WESTERN VIRGINIA
WATER AUTHORITY
CONTRACT 3 - FY17
SANITARY SEWER
REPLACEMENT

EPPERLEY AVE PLAN & PROFILE

C-113

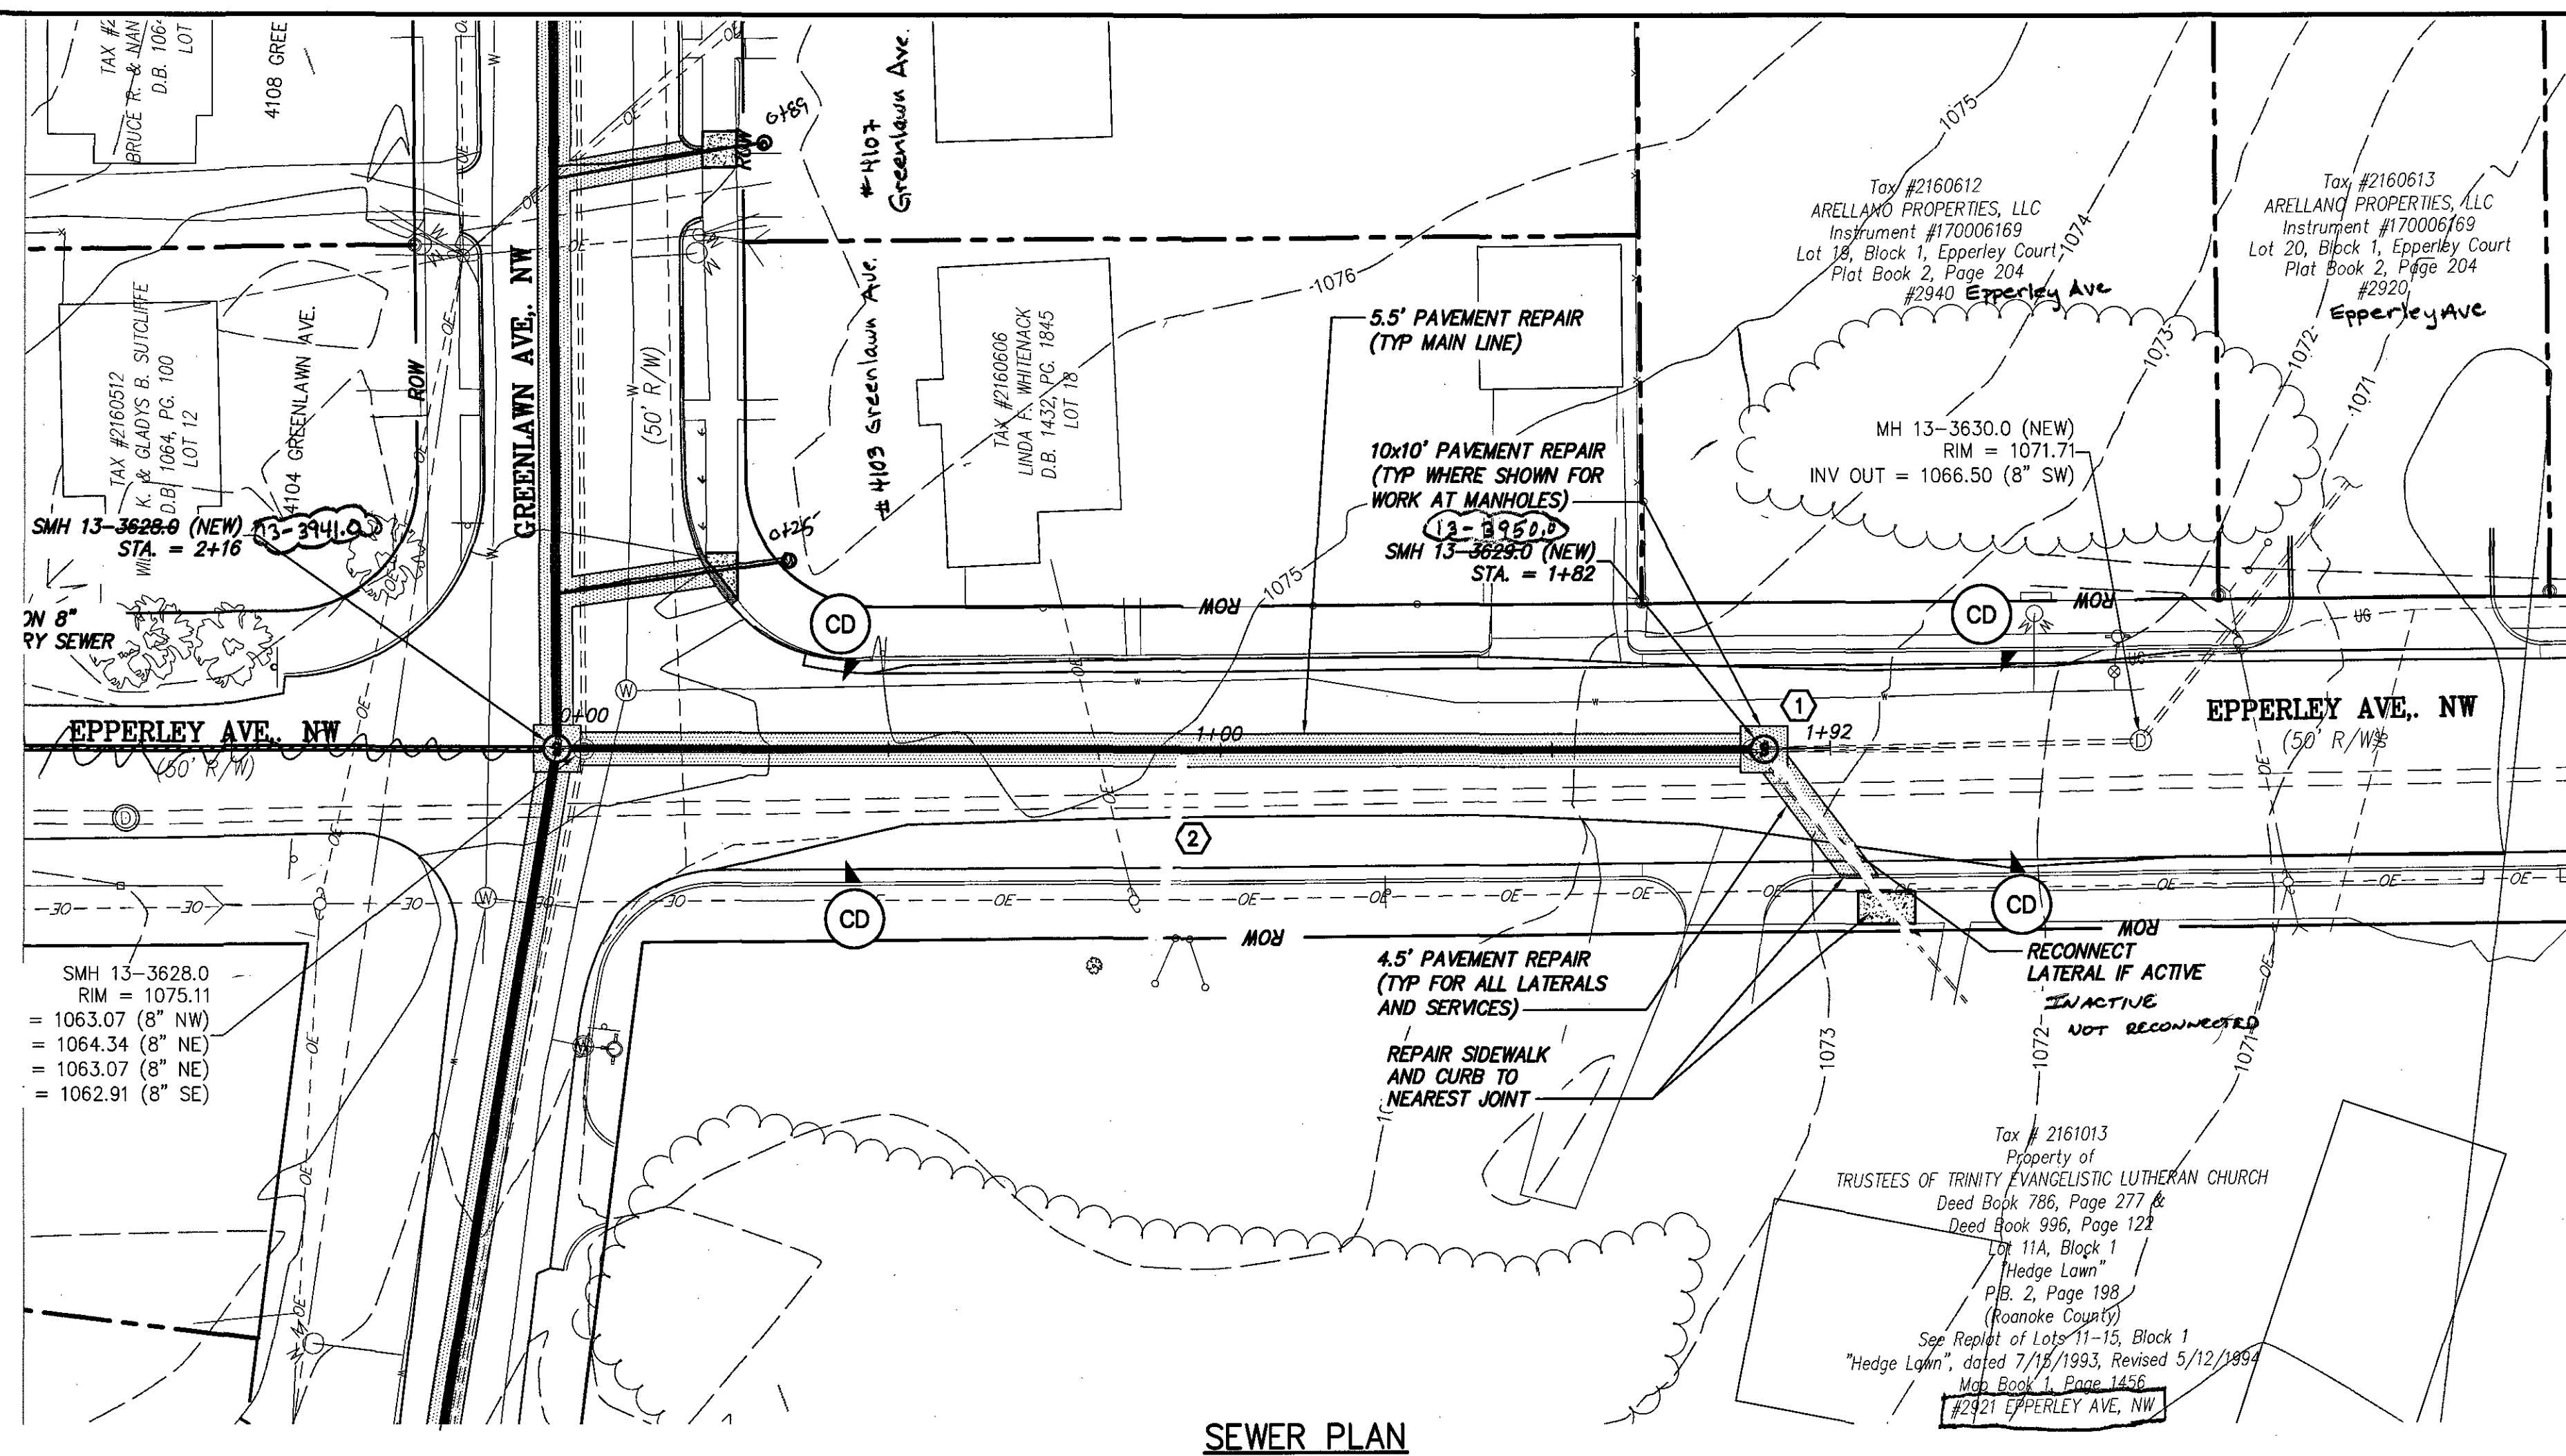
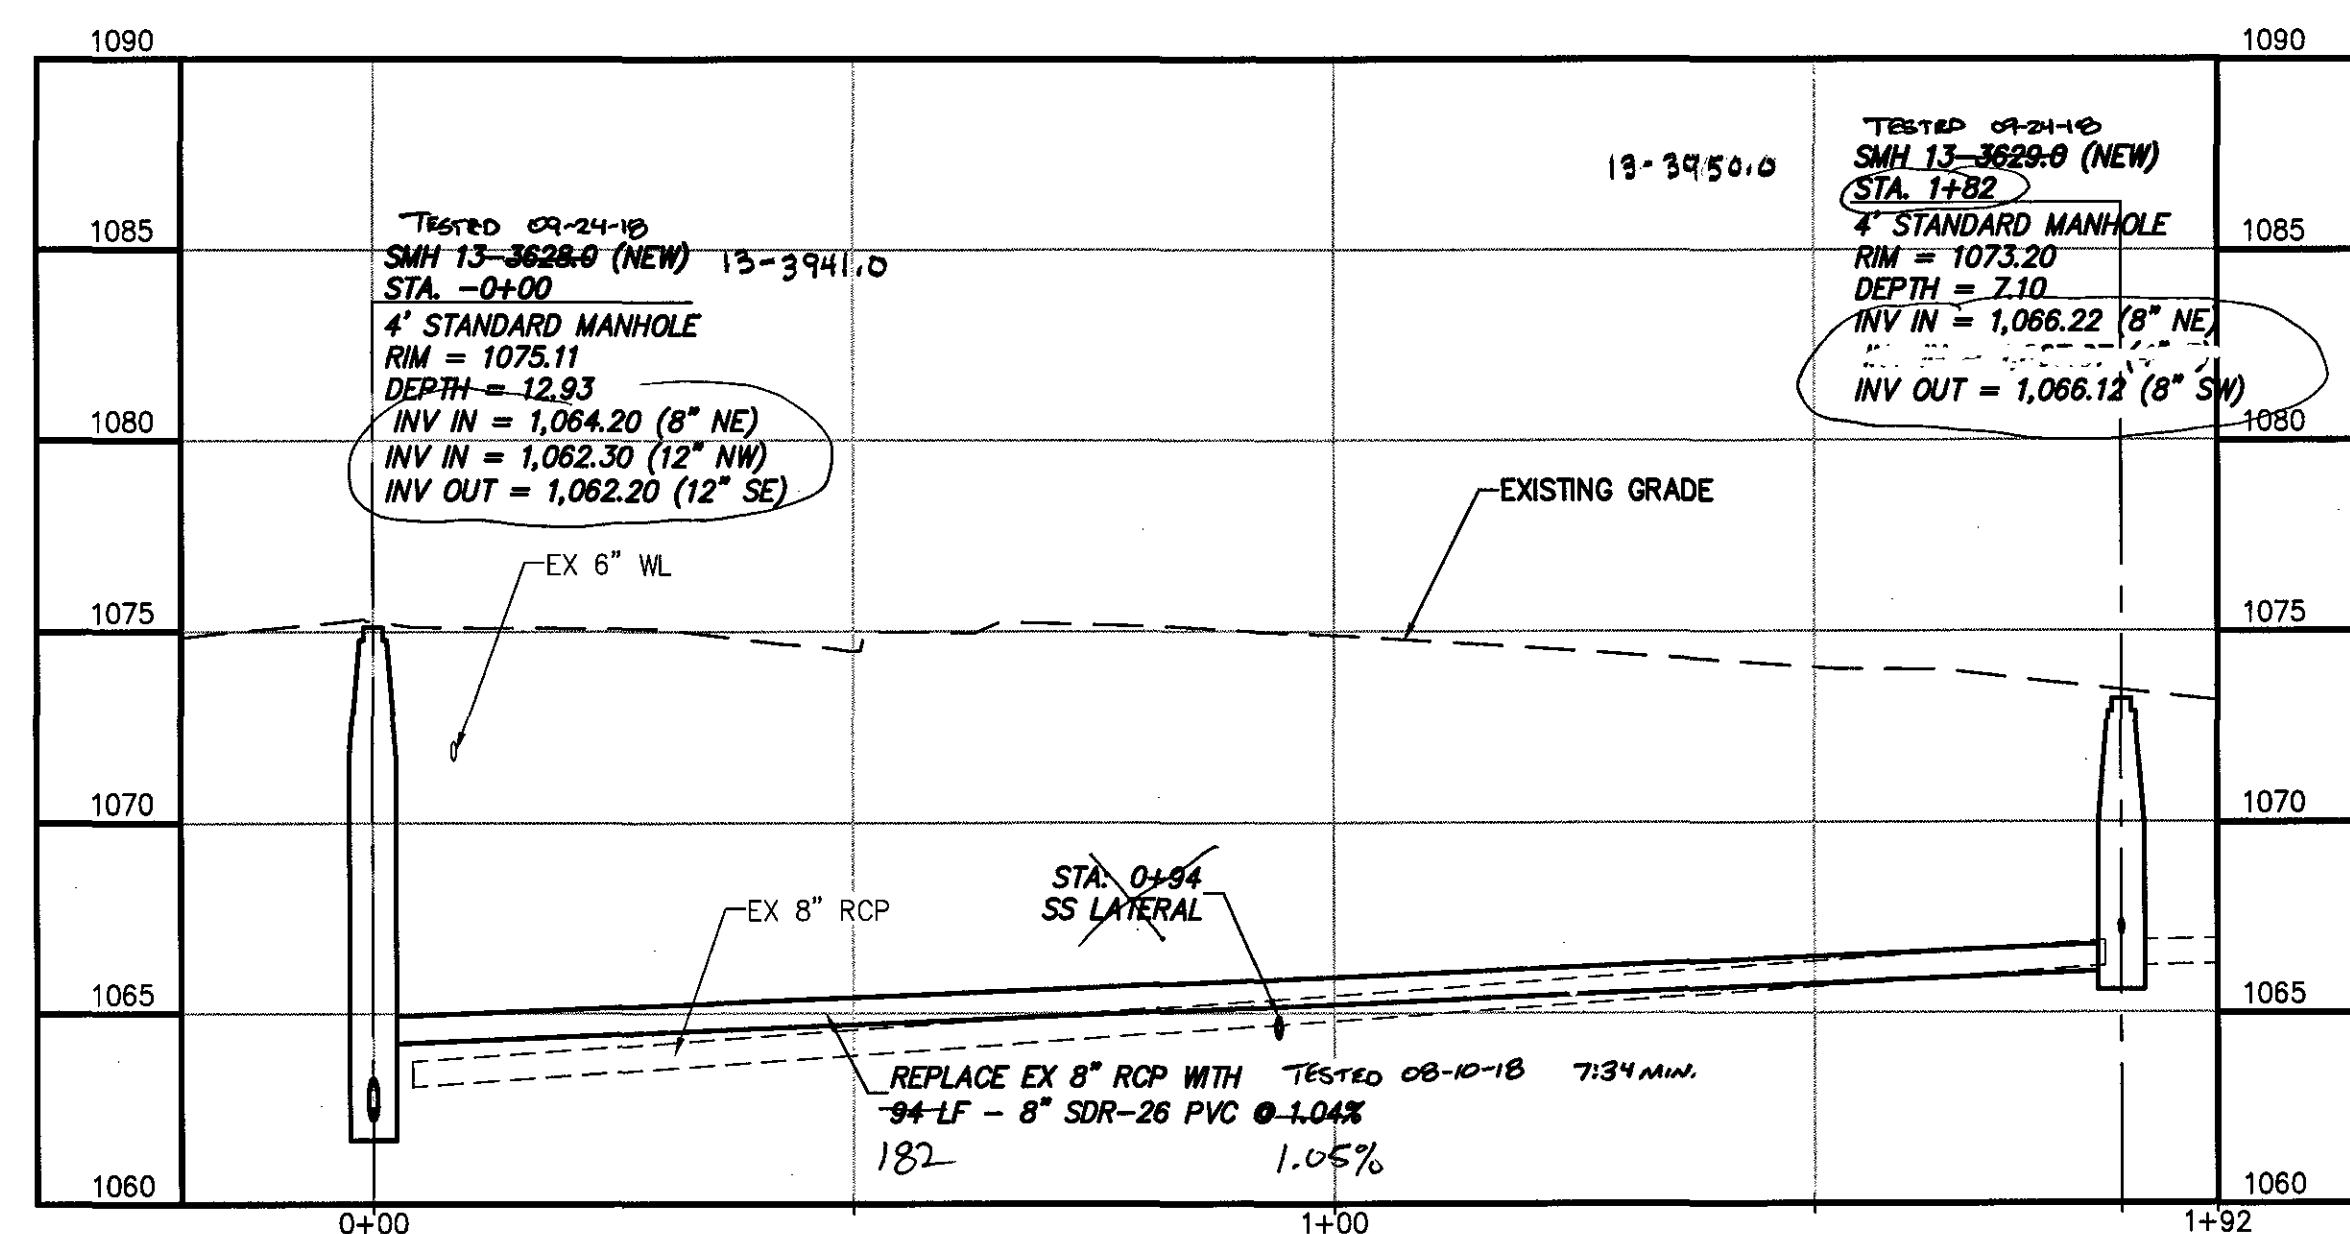
- ① LOCATE SMH 13-3629.0 WHERE UPSTREAM PVC BEGINS. THIS IS APPROXIMATELY 2' UPSTREAM OF IT'S CURRENT LOCATION AS SHOWN ON PLANS.
 - ② CCTV INDICATES A LATERAL ENTERING SEWER AT 12 O'CLOCK. CONFIRM ACTIVE OR ABANDONED. RECONNECT IF ACTIVE, DO NOT RECONNECT IF FOUND INACTIVE.
- INACTIVE. NOT RECONNECTED*
